# **Land East of Junction 11 of the M40, Banbury**

## *Transport Assessment Addendum*

26<sup>th</sup> October 2022  
SJT/RT/23457-06f Transport Assessment Addendum

- 1.5 It is within this context that a Transport Assessment (TA) was prepared which supported a planning application for this development. Oxfordshire County Council (OCC) have commented on this application (ref: 22/01488/OUT) which can be seen in **Appendix B**. This includes a list of transport improvements.

JOB TITLE		LAND AT M40 J11		CLIENT		GREYSTOKE	
DRAWING TITLE							
M40 Junction 11 Gyratory							
SCALE	DRAWN BY	DATE	DRAWING No	REVISION			
1:1000@A1	RM	04/10/22	23459-06-02-GA	A

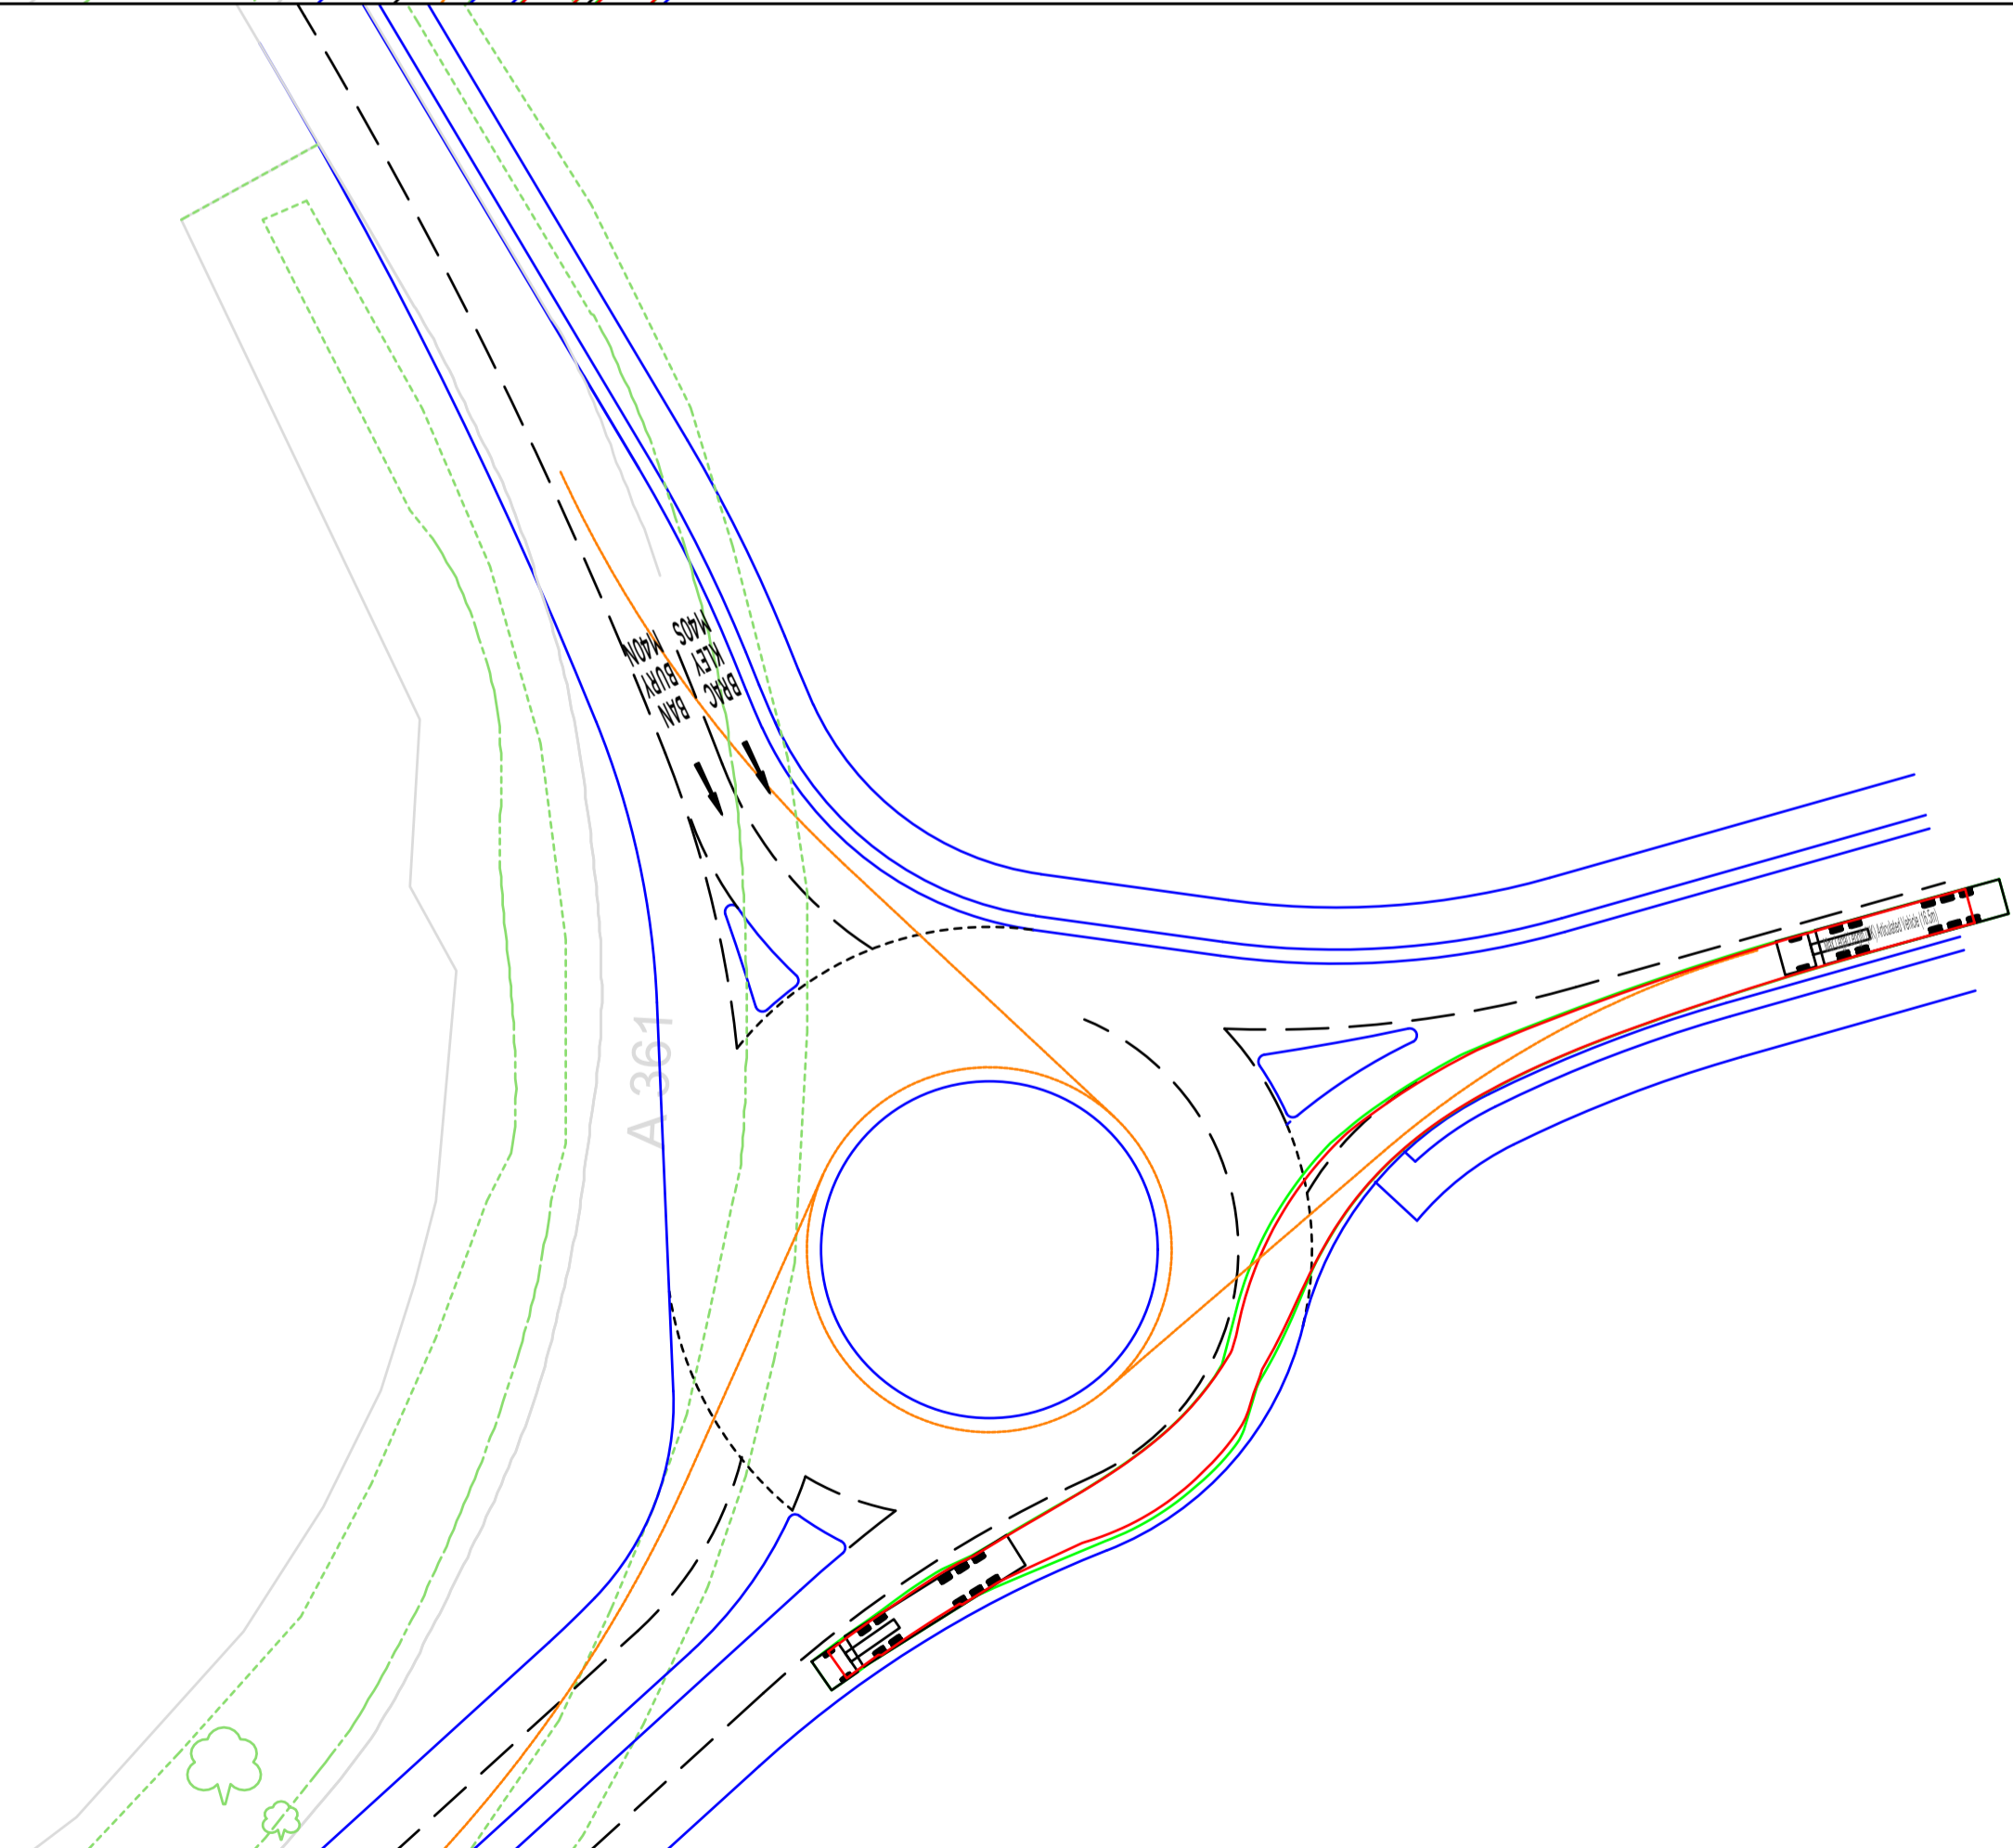
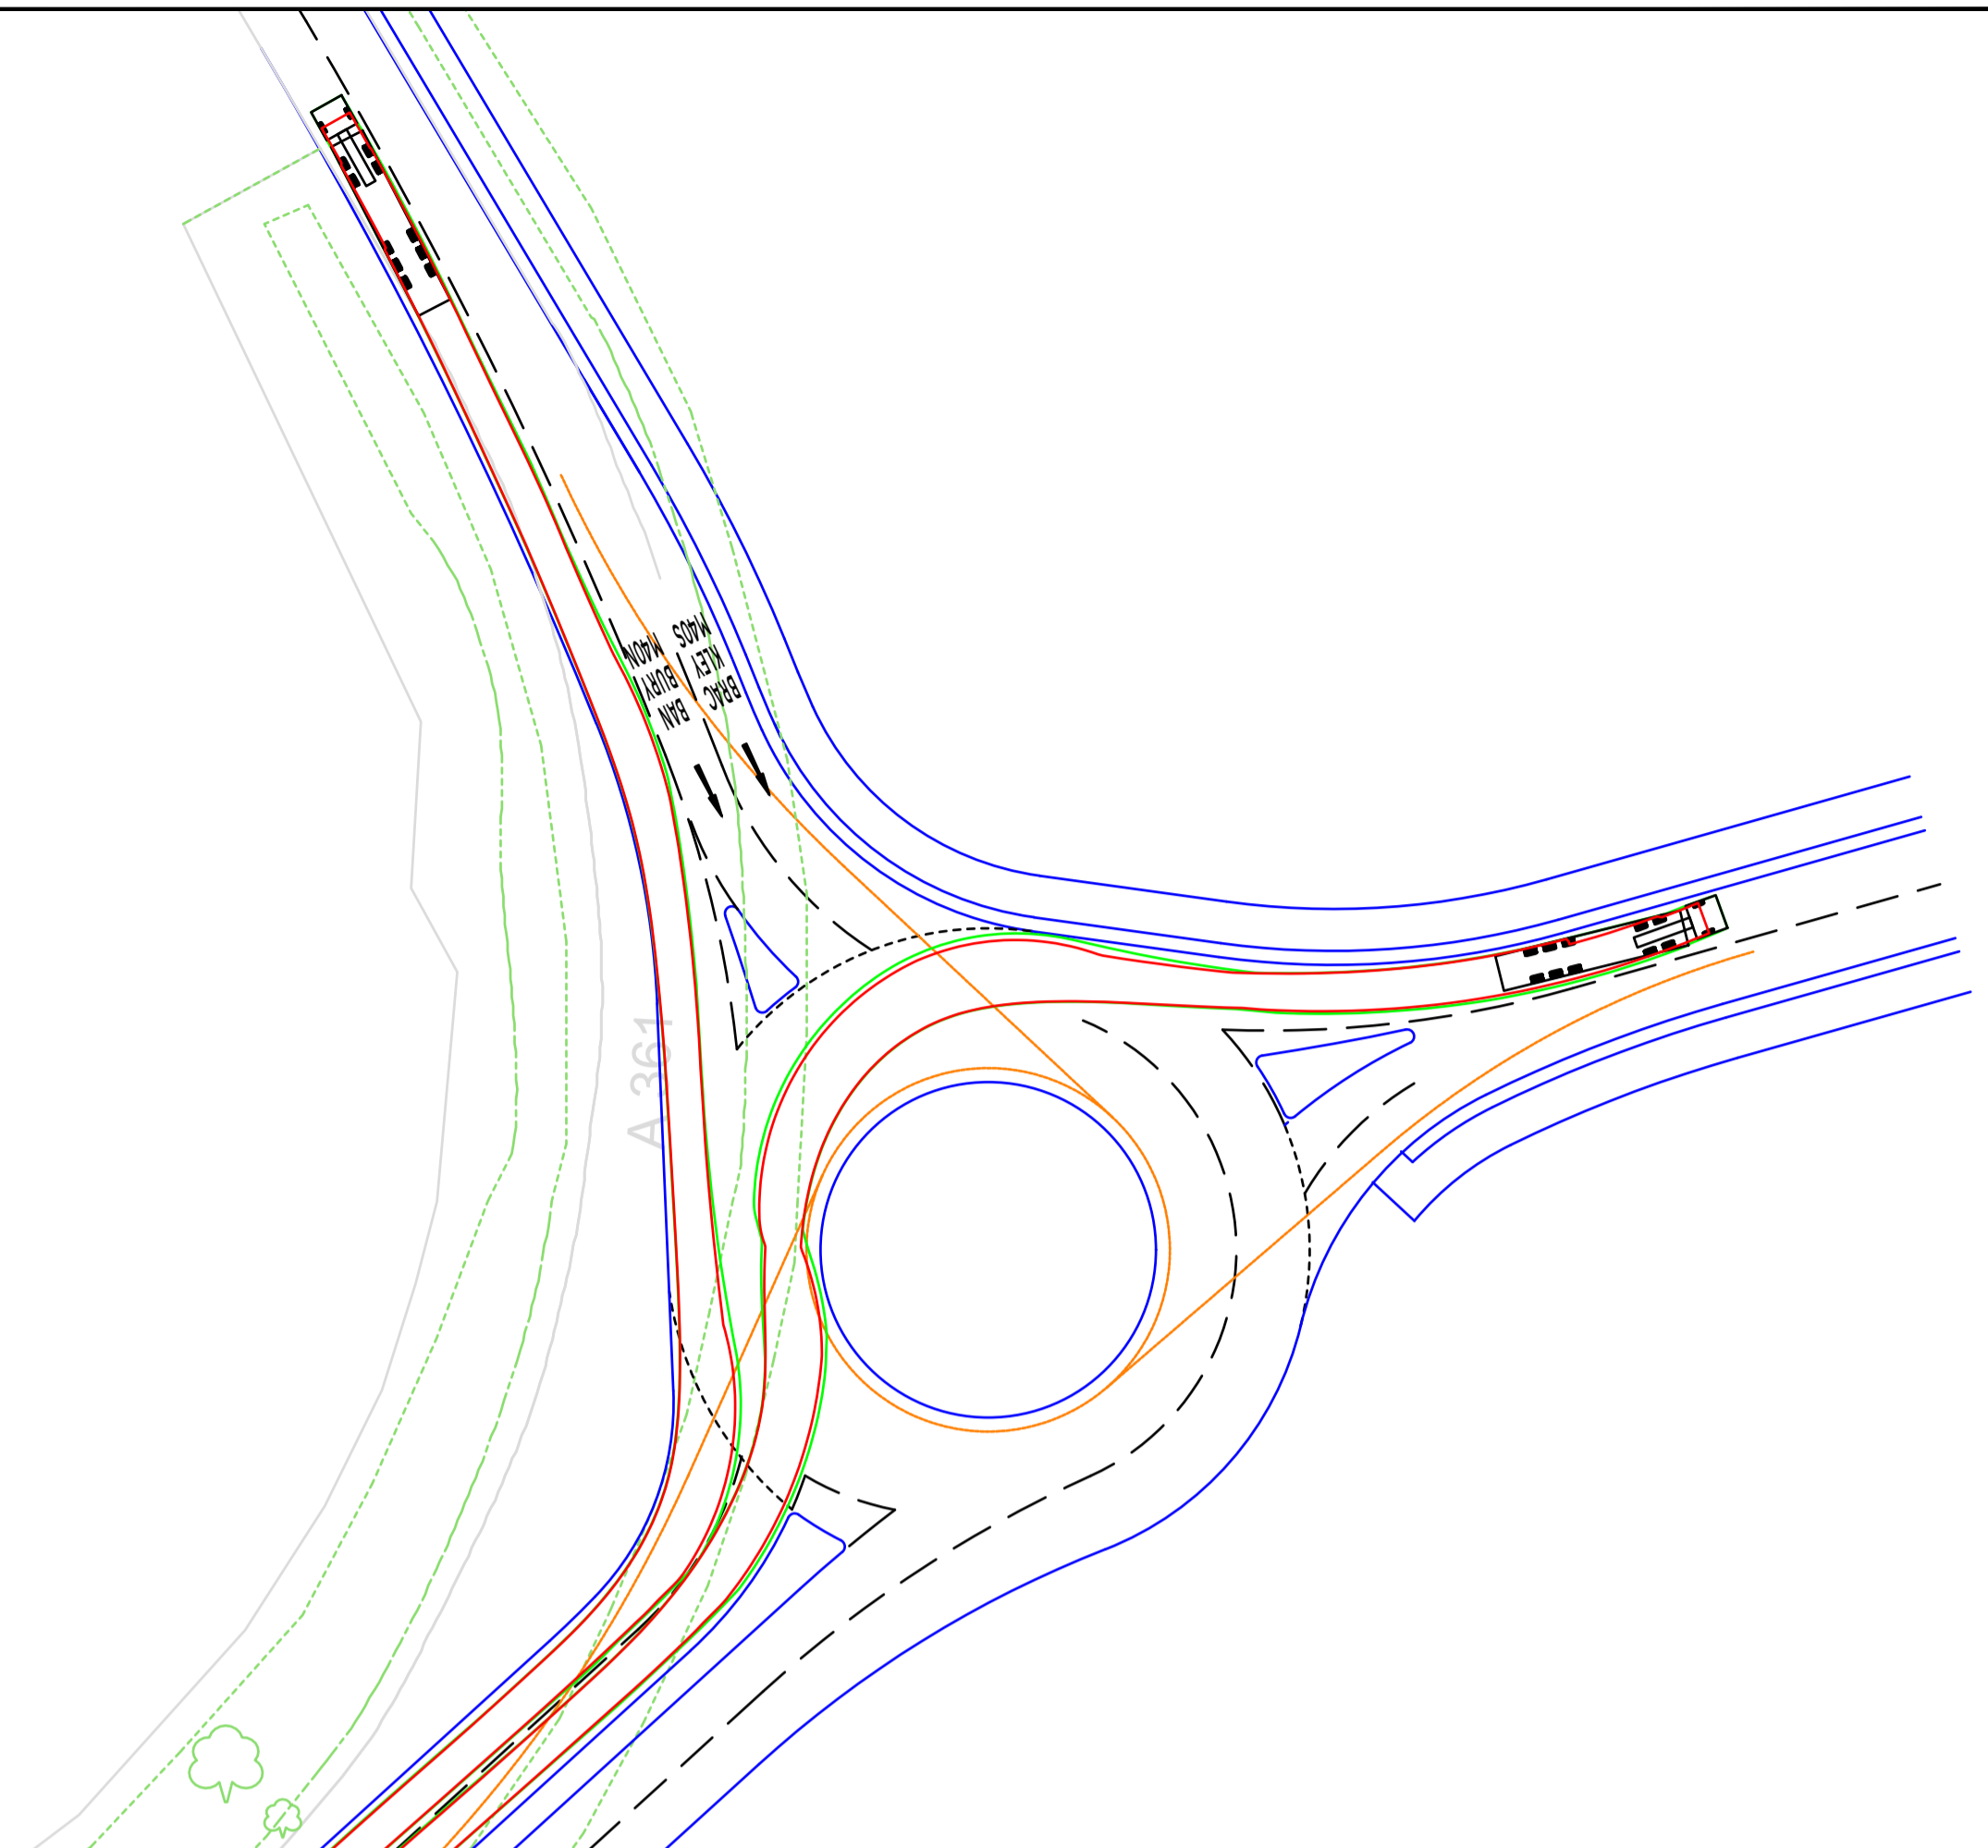
*length of queues and the resulting congestion in the area. It has not been demonstrated in a VISSIM simulation that widening the A361 to two lanes between the proposed and existing roundabouts, and increasing the gyratory entry flare to three lanes, is sufficient to mitigate for the effect of the additional vehicles. Also, it has not been demonstrated that these proposed highway modifications are feasible, considering the level differences between the carriageway and the surrounding land.*

- 9.12 The proposed mitigation will provide an additional entry lane and significantly more stacking space. As can be seen in **Table 5** the performance of the junction is significantly improved and the potential for queuing has significantly reduced relative to the baseline. The mitigation therefore more than offsets the development demand. With respect to an interaction between the junctions, this is unlikely to occur in practice as the layout of the site access provides significant spare capacity to maximise its resilience.

- 9.13 The widening of link between the site access and the adjacent gyratory requires additional land only from within the site boundary and there is no constraint to the ability to provide the required side slopes.
- 9.14 To further improve the performance of the A361 arm, the entry can be signalised. This has been modelled on the basis of two entry lanes (rather than the three that would
